WORK ORDER NON-CONFORMANCE / UPDATE

Work Order: <u>142806</u> Part No. <u>D3608-1</u> NCR No. _____		DISPOSITION Rework ☒ Scrap ☐ Use-as-is ☐ Suspected Unapproved ☐		AGAINST DEPARTMENT/PROCESS Skid-tube ☐ Cross tube ☐ Water Jet ☐ Engineering ☒ Machining ☐ Small Fab ☐ Prod. Eng. Coord. ☐ Quality ☐ Thermoforming ☐ Finishing ☐ Rec/Store/Packaging ☐ Other ☐ Large Fab ☐ Composite ☐ Supplier ☐					
Date: <u>16-03-21</u>		Step #: <u>100</u>		QTY Effective: <u>1</u>			MRB (QSI042) Approval		
Description Work Order Deviation				Disposition				DAS 12 9-89 16/3/11	
Do not drill the 3 indicated holes.				Acceptable deviation - Customer will transfer drill holes to Ø0.161 per figure 4 of IIN				Completed By DAS 12 9-89 16/3/11	
								Lead hand / Supervisor Approval Verification DAS 9 9-89 16-03-21	
								QC / QA Coordinator Approval DAS 9 9-89 16-03-21	
Root Cause Environment ☐ No Re-verification ☐ Design ☐ Operator ☐ Doc/Data ☐ Offset/Setup ☐ Equip/Tooling ☐ Supplier ☐ Handling/Pre ☐ Training ☐ Material ☒ Use for Testing ☐ Internal Transport ☐ Poor Information ☐ Tribal Knowledge ☐ Rushing ☐ LOA ☐ Product Improvement ☐ Substation ☐ Process Improvement ☐ Past Expiry Date ☐ Manufacturing Pro

DRAWING NO.
D3608
REV. C
SHEET 1 OF 2
TITLE
DOUBLER
SCALE
NTS

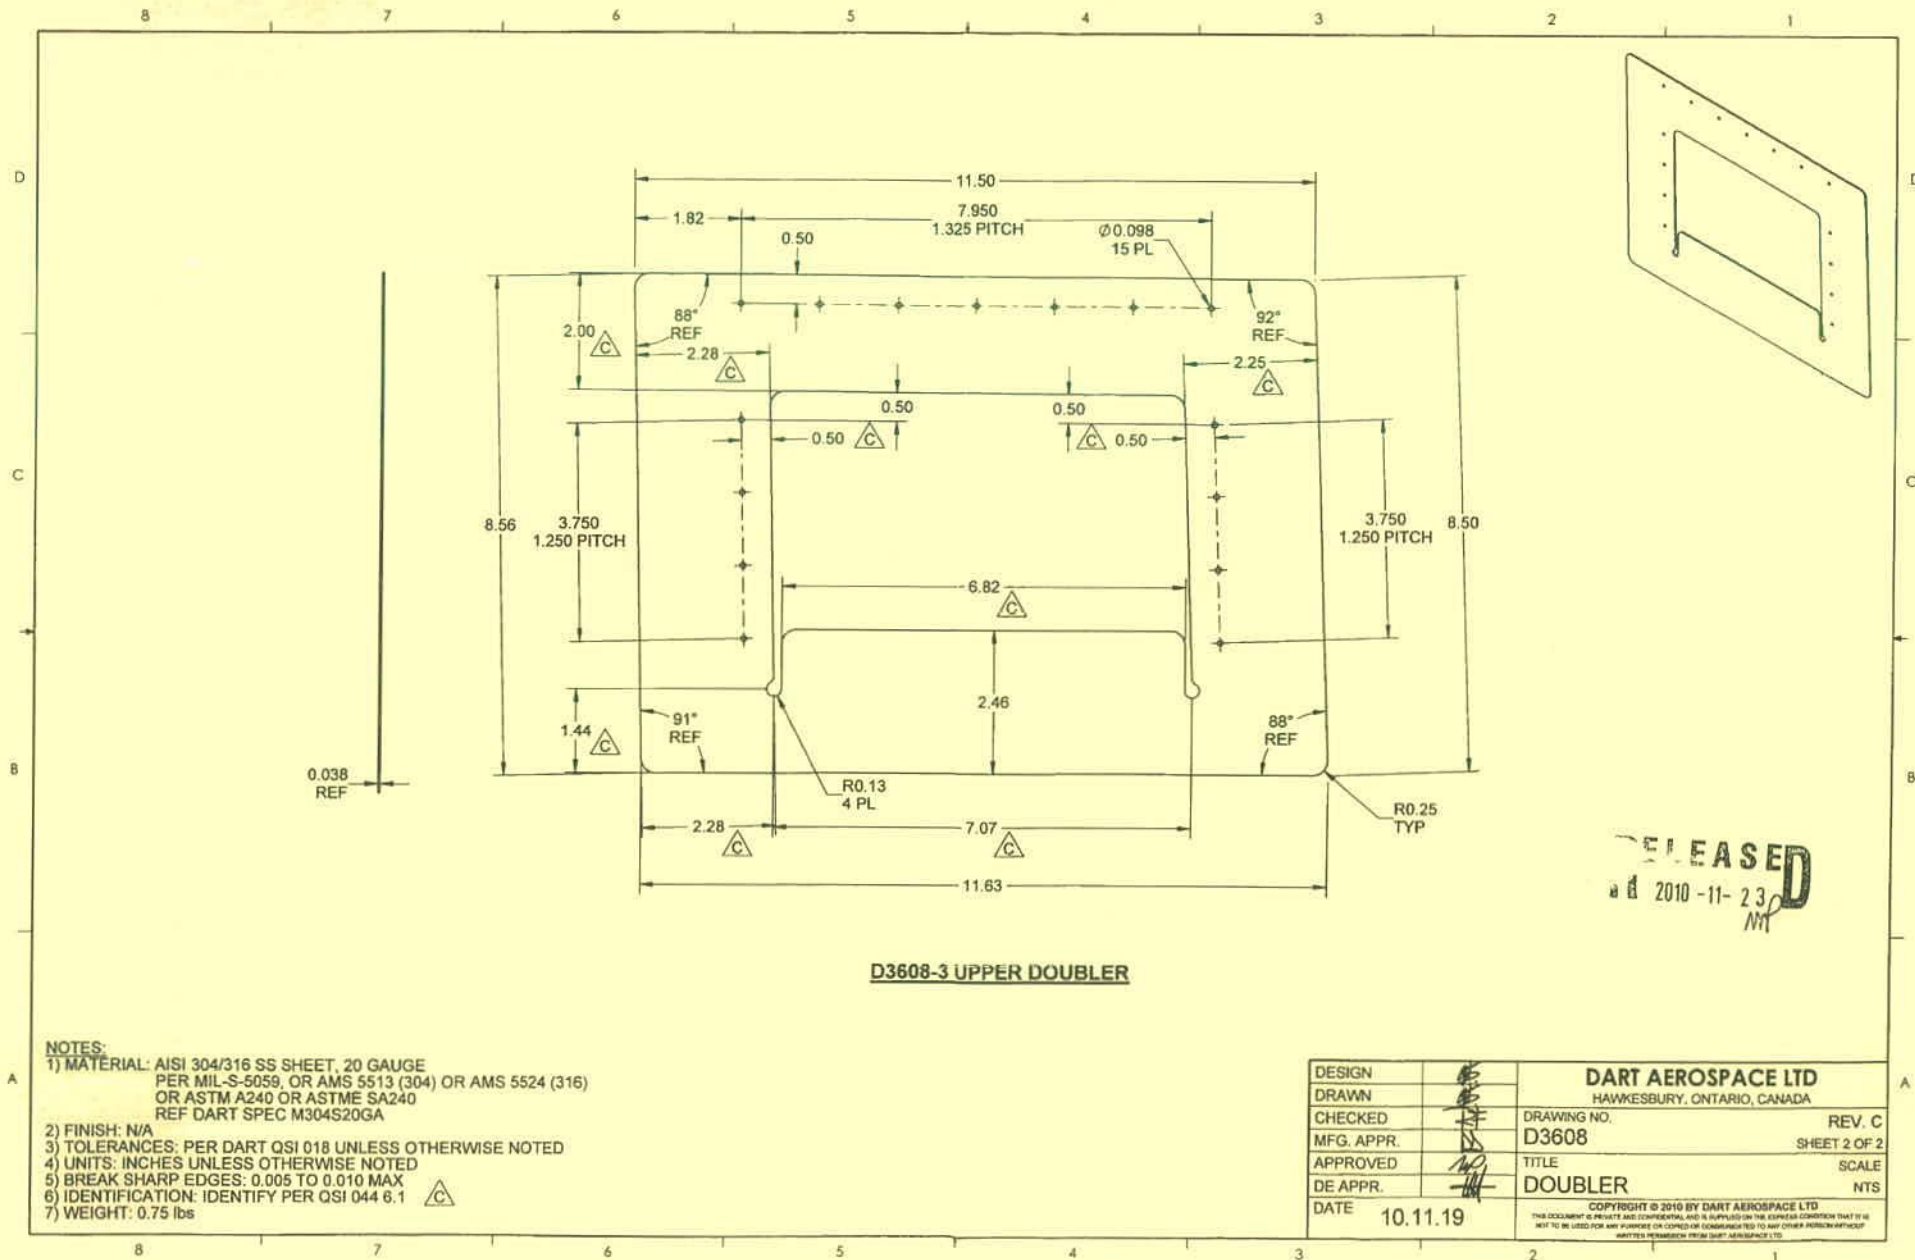
If shipping to Bell Helicopter Mirabel: must ship D412-775-013 with D3608-1 minus 3 holes as per attached. Eng. to sign off deviations on W/Os.
